ENGINE - HP TURBINE - PROVIDE A TURBINE CASE AND VANE ASSEMBLY THAT WILL ALLOW
INDIVIDUAL FIRST STAGE DUCT REPLACEMENT - CATEGORY CODE 8 - MOD.ENG-72-0092

- (1) This Service Bulletin permits the individual replacement of the Stage 1 HPT Duct Support Assemblies.

V2500-ENG-72-0092

Location of Stage 1 HPT Duct Support Assembly
Fig.1

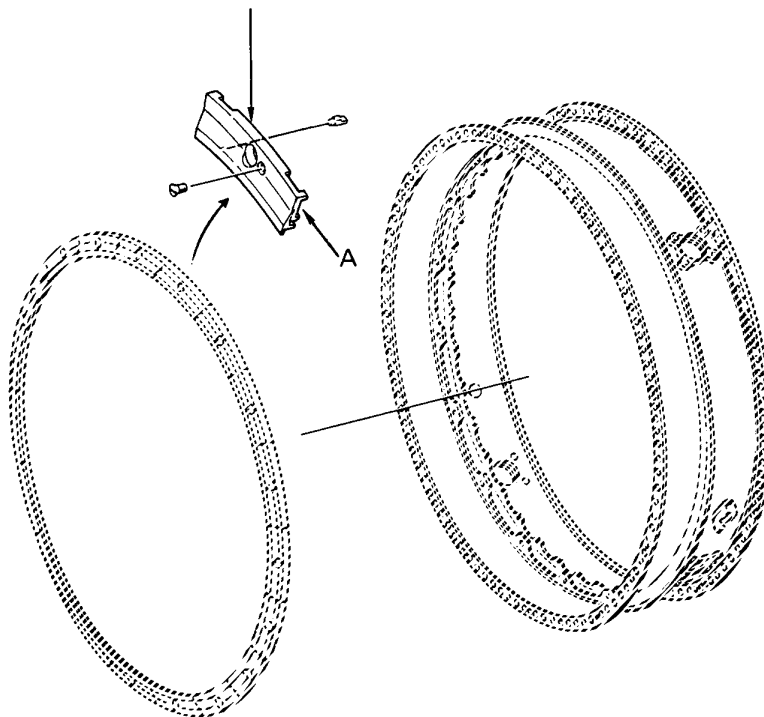
REMOVE PN 2A0177 STAGE 1 HPT DUCT SUPPORT
SET AND INSTALL PN 2A1313 STAGE 1
HPT DUCT SUPPORT ASSEMBLIES (19 Off)

Modification of Stage 1 HPT Duct Support Assembly
Fig.2 (Sheet 1 of 2)

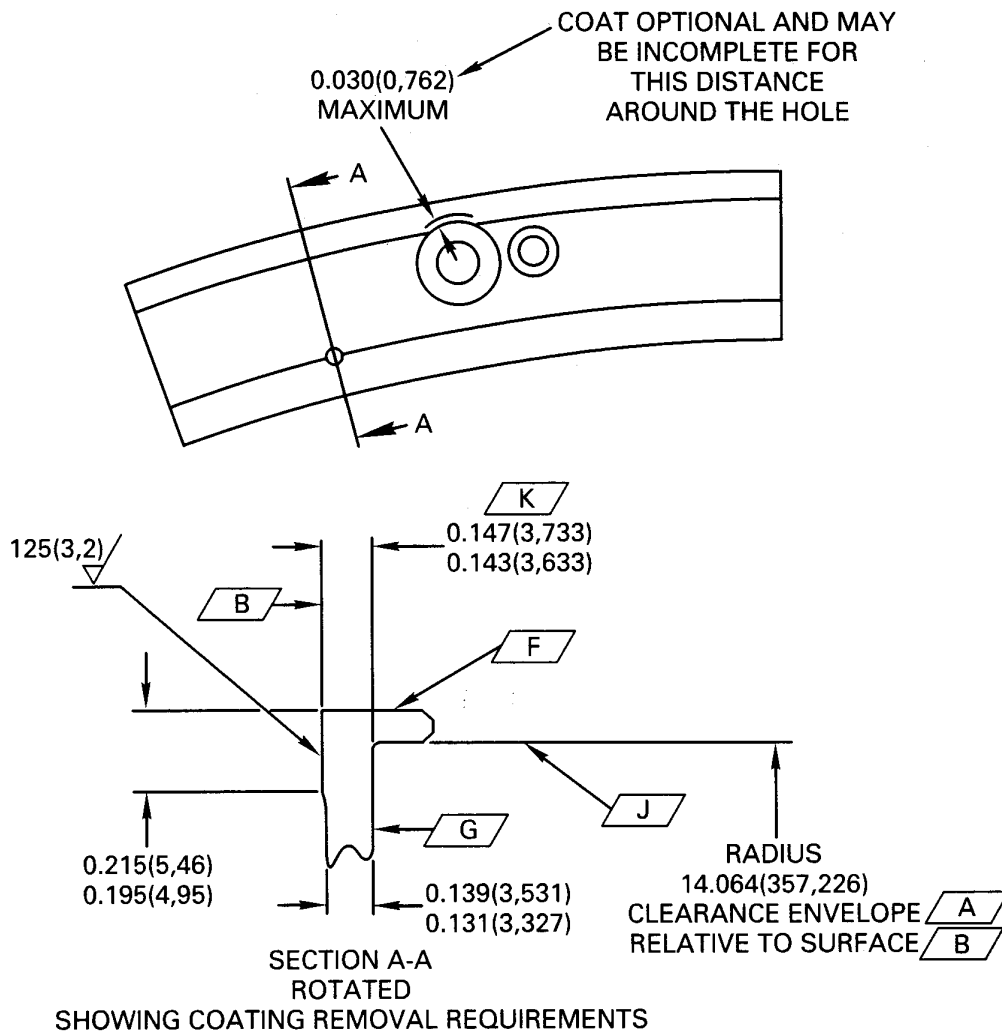
Procedure	Supplementary Information	
(a) Do an inspection of each segment for Dimension L	Refer to the requirements in Fig.1 and 2	
(i) If the duct segment is in the limit, mark the new part number adjacent to the old part number. Use the vibration peen method	Old Part Number	New Part Number
	2A0178	2A1313
	Refer to Reference (2) Control No./TASK No.70-09-00-400-501	
(ii) If the duct segment is not in the limit, go to step (b)

(b) For parts not in the limit, do the modification which follows:	Refer to the requirements in Fig.1 and 2	
(i) Machine surface B to get Dimension K. Remove the minimum amount of material and keep the maximum material thickness	Refer to the requirements in Fig.2. Use the IAE 3P16273 Grind Fixture	
(ii) Coat by the procedure specified to get a 0.002 - 0.008in. (0,051 to 0,203 mm.) thickness after finish machining. No coat permitted in holes	Refer to the Reference (2) Control No./TASK No.70-34-03-340-501	
(iii) Finish machine to the dimensions specified	Refer to the requirements in Fig.2. Use the IAE 3P16273 Grind Fixture	
(iv) Mark the new part number adjacent to the old part number. Use the vibration peen method	Old Part Number	New Part Number
	2A0178	2A1313
	Refer to References (2) Control No./TASK No.70-09-00-400-501

Family Tree - Turbine Case and Vane Assembly
Fig.3

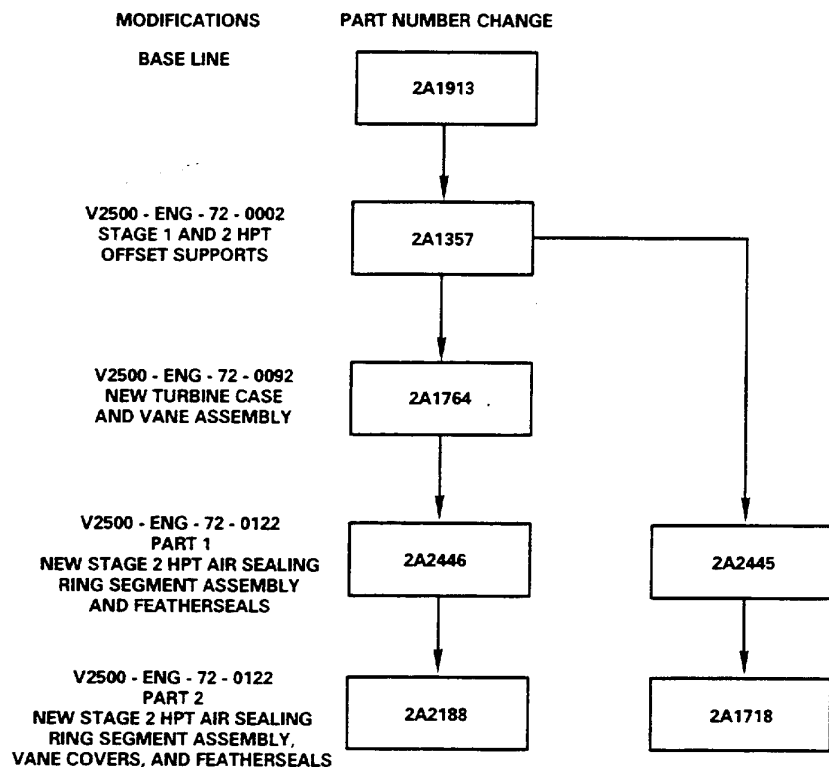
- (1) When the Turbine Case and Vane Assembly is assembled by Reference (3) Chapter/Section 72-45-20 Assembly-01, use the 2A1313 Stage 1 HPT Duct Support Assemblies (19 off).
- (2) Identify the new Turbine Case and Vane Assembly part number as given below. Use the vibration peen method given in References (2) Chapter/Section 70-09-00, Marking of Parts.

2A1357

2A1764
